CONTRACT NO. DE-AC27-01RV14136 – TRANSMITTAL OF THE U.S. DEPARTMENT OF ENERGY, OFFICE OF RIVER PROTECTION (ORP) DESIGN ASSESSMENT REPORT NUMBER D-06-DESIGN-031: REVIEW BECHTEL NATIONAL, INC. (BNI) GLASS FORMER STORAGE FACILITY (GFSF)

**DESIGN OVERSIGHT REPORT**

**REVIEW  
BECHTEL NATIONAL, INC.  
GLASS FORMER STORAGE FACILITY (GFSF)**

**DESIGN OVERSIGHT: D-06-DESIGN-031**

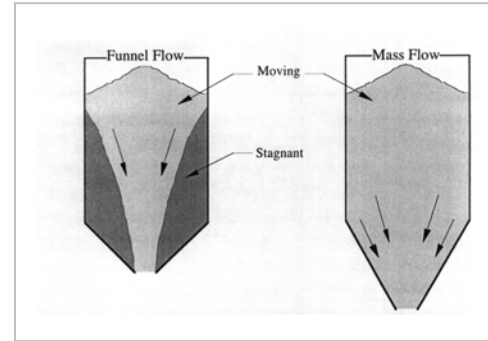
- GFC MIXER AND RECIPE LAW 44: Testing confirmed that a 4% liquid addition by weight will be added to effectively mitigate airborne dust. However, as water was added, a GFC buildup was found on the paddles and corners of the mixer. The design of the Bella 10,000-XN mixers has been modified to minimize these buildup areas by adding nylon-coated agitator paddles, and reducing the total flat surface area on the interior of the mixer.

- GFC MIXER AND RECIPE HLW 98-96: Testing confirmed that a 5% liquid addition by weight will be added to effectively mitigate airborne dust. However, as water was added, a GFC buildup was found on the paddles and corners of the mixer. As more water was added, the GFCs adhered to the inside of the mixer and lumps started to form. The lumps ranged from 1/8 inch to approximately 1/2 inch in diameter, and were soft and easily broken when squeezed.

The design of the Bella 6,000-XN mixers is being modified to minimize the GFC buildup areas by adding nylon-coated agitator paddles and reducing the total flat surface area on the interior of the mixer. Also, to break up the lumps, another pin mill operation to the post-mix cycle is being added.

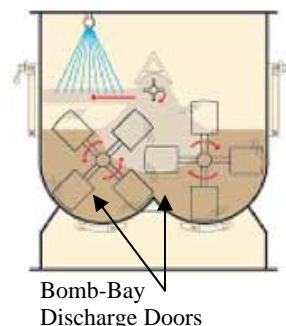
c. **Dust Control and Water Addition:** The DA pilot test demonstrated that LAW and HLW mixers required an addition of 4% to 5% (by weight) liquid to effectively mitigate airborne dust. The blue area in the sketch to the right shows the liquid addition area.

- Since the GFCs within the LAW and HLW mixers tends to agglomerate and lump when water is added, a liquid flow distortion bar will be used to improve performance. The bar consists of a rapidly rotating bar with pins located close together to create a moving curtain of material over the paddles during mixing.

Figure 7-1. Main Elements of the UPS System

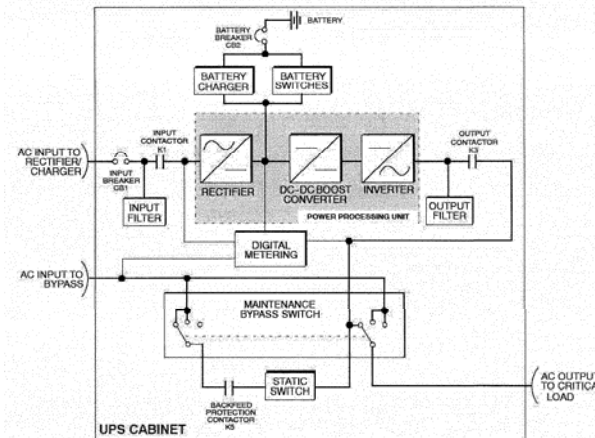
20. Explain UPS scheme as shown on DRWG # 08-00069 with respect to inverter, battery, etc.	Ramsay	See attached diagram. If there are additional questions they will be addressed separately. ORP NOTE: UPS diagram is sufficient for current level of GFSF design completion. See Diagram below; last page.

REFERENCE ORP LOI no. 20 and BNI response above:  
 DRAWING No. 24590-CM-POA-MH00-00001- 08-00069 with respect to inverter, “Main Elements of UPS System”
